# Technical Service Bulletin

SUBJECT:			No: <b>TSB-19-13-002</b>
<b>ENGINE STALLING IN COLD CONDITIONS WITH SPECIFIC OPERATIONS</b>			DATE: <b>February 2019</b>
			MODEL: <b>2018-2019 Eclipse Cross</b>
<b>CIRCULATE TO:</b>	<input type="checkbox"/> GENERAL MANAGER	<input checked="" type="checkbox"/> PARTS MANAGER	<input checked="" type="checkbox"/> TECHNICIAN
<input checked="" type="checkbox"/> SERVICE ADVISOR	<input checked="" type="checkbox"/> SERVICE MANAGER	<input checked="" type="checkbox"/> WARRANTY PROCESSOR	<input type="checkbox"/> SALES MANAGER

## PURPOSE

## ENGINE ECU REPROGRAMMING CHART

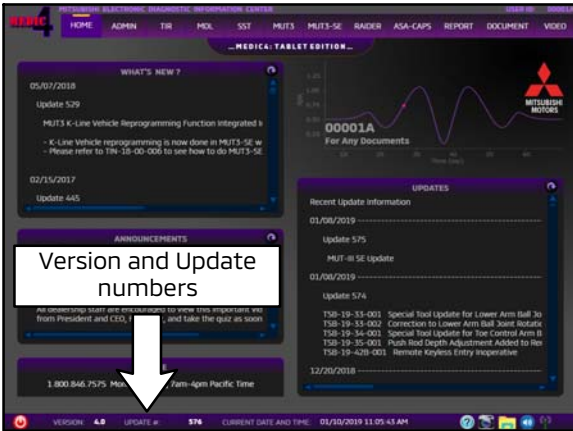
In cases where a gas tank is filled with winter blend fuel, engine stalling may occur in cold weather conditions, after the specific operations below:

This may be due to inappropriate fuel correction data after engine restart, where the Air/Fuel (A/F) ratio becomes rich, resulting in the engine stalling.

This TSB instructs dealers to reprogram the Engine ECU with updated software to correct the issue.

Model	Engine ECU Part Number	Data Number	Software Part Number	
			Previous	New
2018 Eclipse Cross	1860D116	1862C955	1860D11603 1860D11602 1860D11601	1860D11604
2019 Eclipse Cross	1860D402	1862C956	1860D40201 1860D40200	1860D40202
